W3F1-2003-0094

Subject: Core Operating Limits Report – Cycle 13 Revision 1
Waterford Steam Electric Station, Unit 3 (Waterford 3)
Docket No. 50-382
License No. NPF-38

**Waterford 3 Core Operating Limits Report
Cycle 13, Revision 1**

ENTERGY OPERATIONS
WATERFORD 3
CORE OPERATING LIMITS REPORT
FOR CYCLE 13
REVISION 1

COLR Figure 6

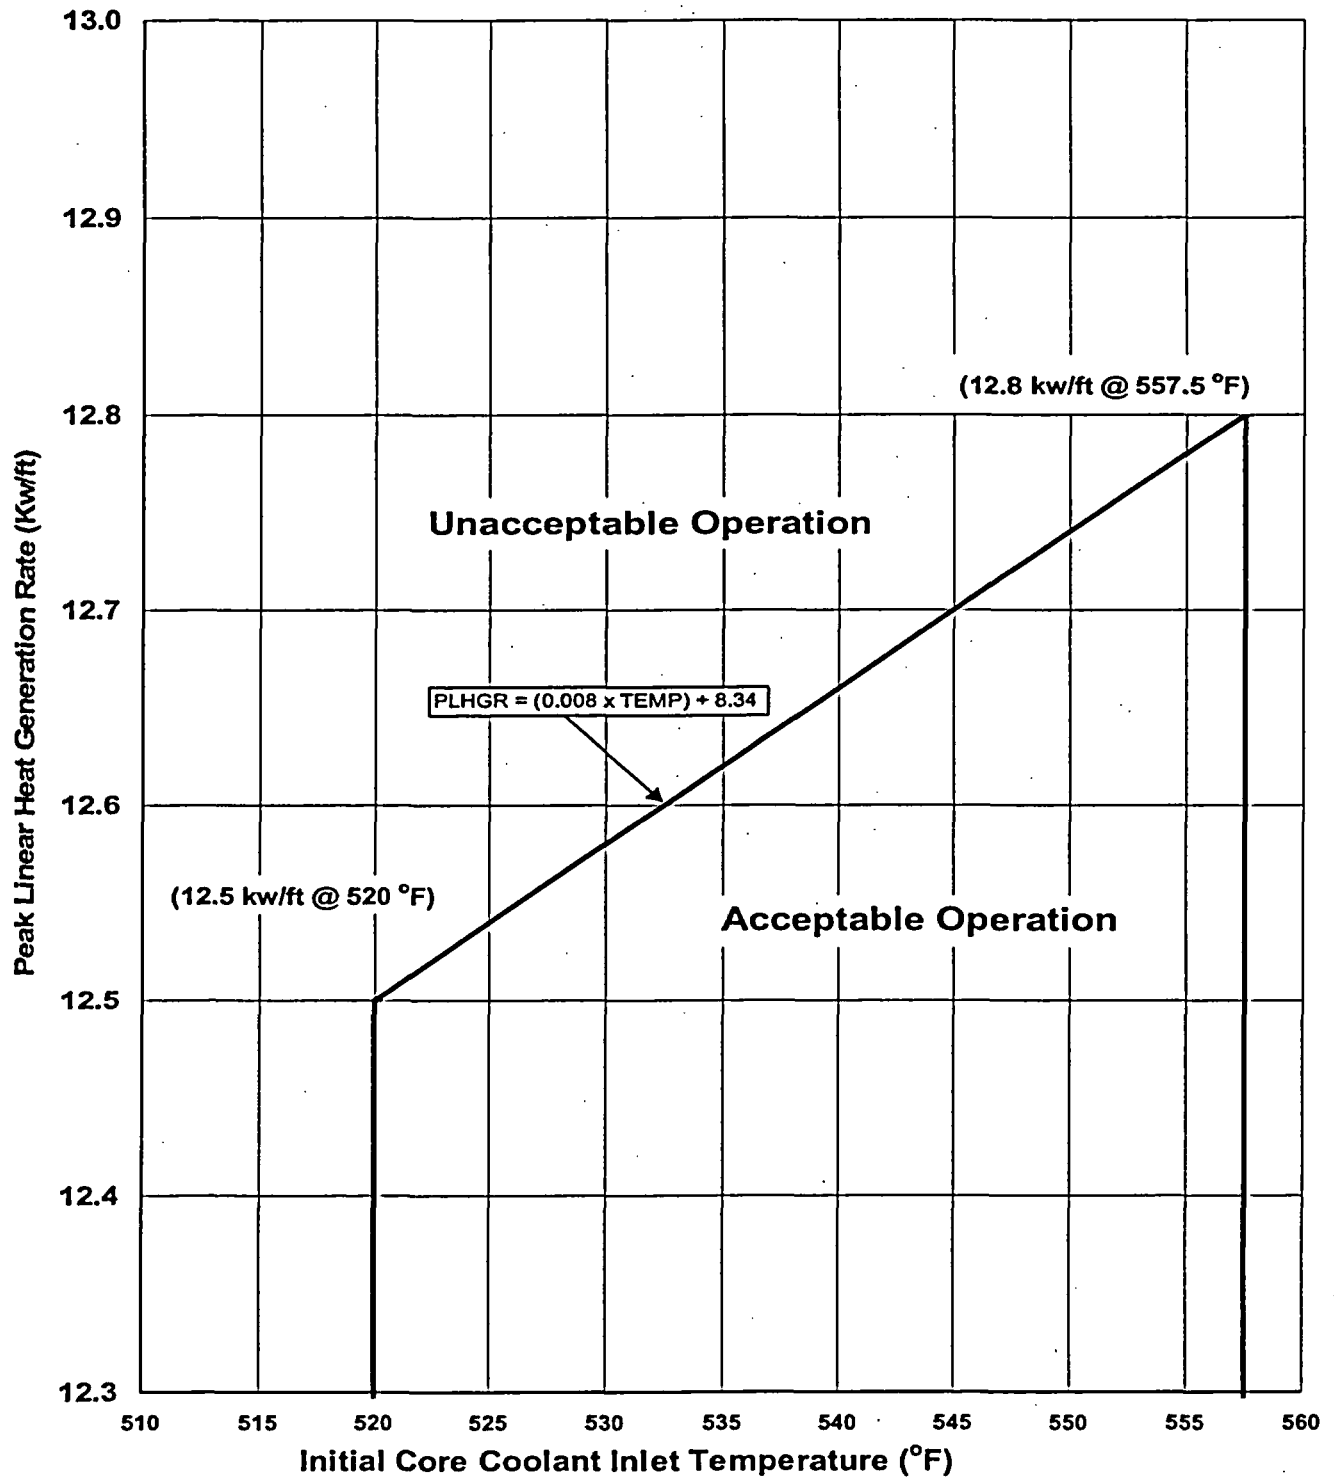
- Figures 6 & 7 were revised to provide vertical lines from the endpoints of the plotted line to the temperature axis. Also, the equation for the plotted line was added.

- Figures 6 & 7 were revised to implement a 0.1 KW/FT reduction for the specified temperature range to account for greater than 500 but less than 600 plugged tubes in Steam Generator #1 (Ref. ER-WF3-2003-0117-000)

COLR Figure 8A

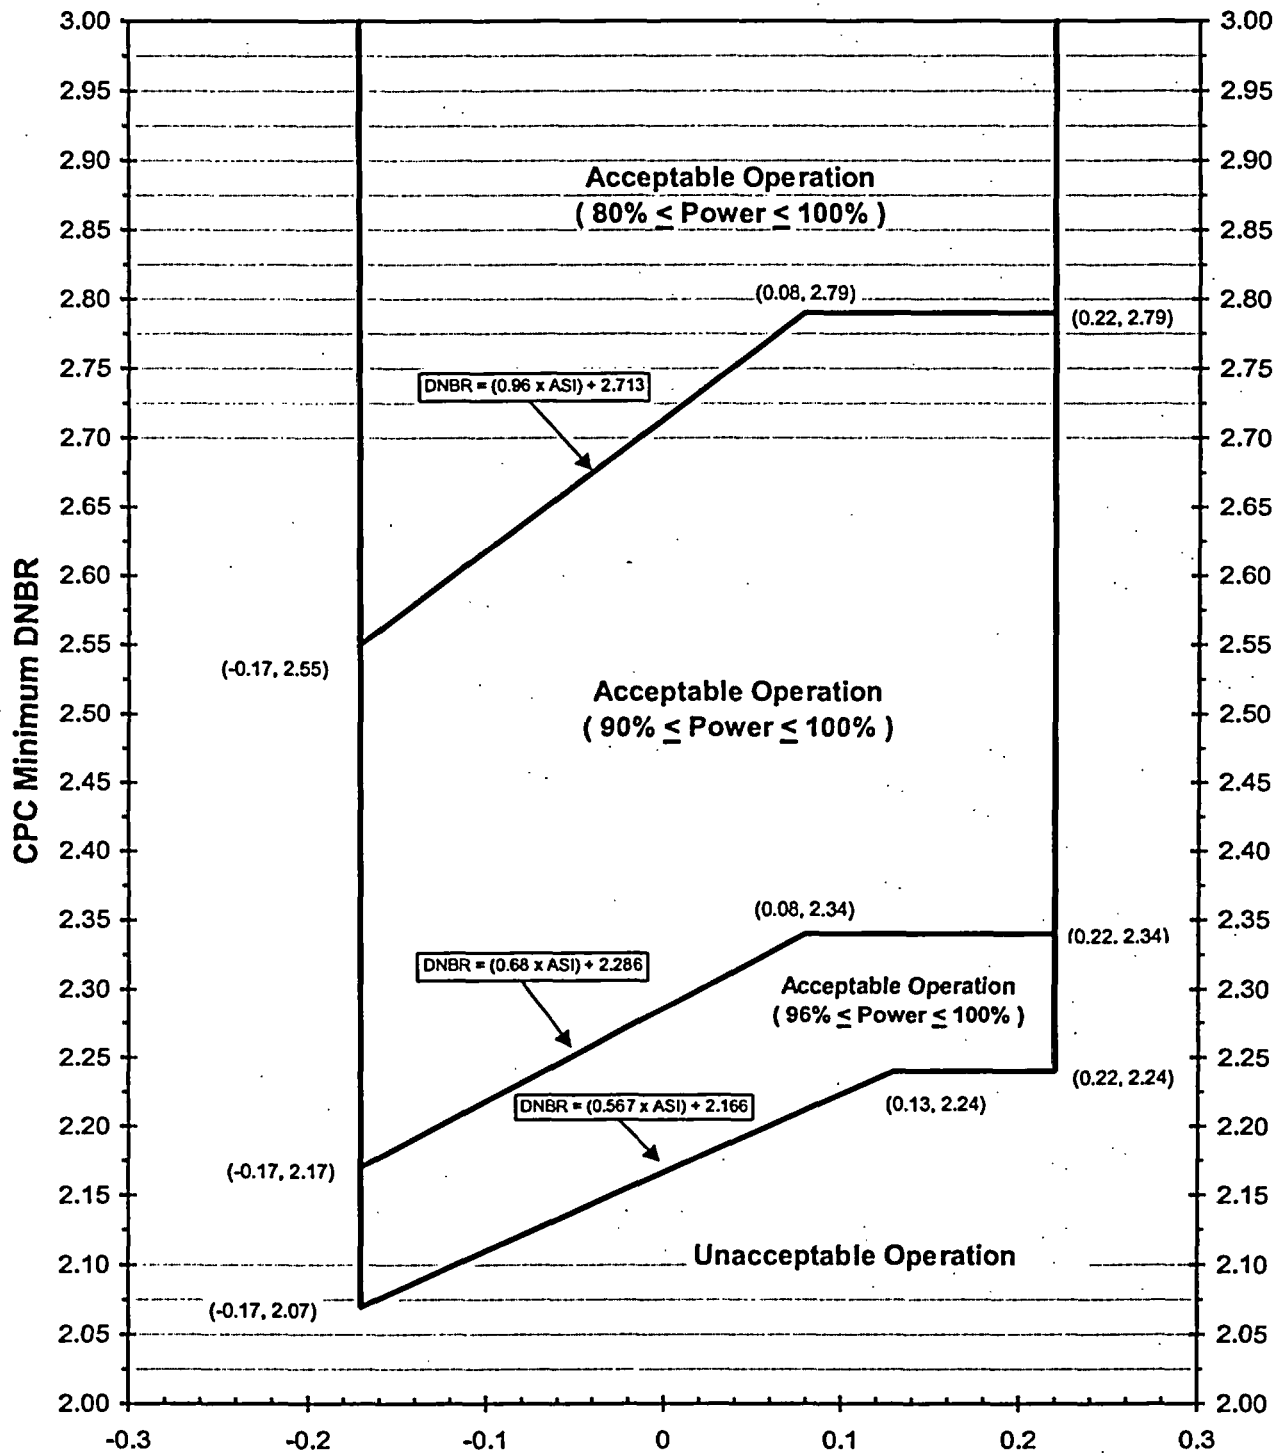
- Figure 8, was revised to incorporate cycle-specific limits for Cycle 13.
- Figure 8A, was added to provide better resolution for the three power ranges in the lower portion of Figure 8.
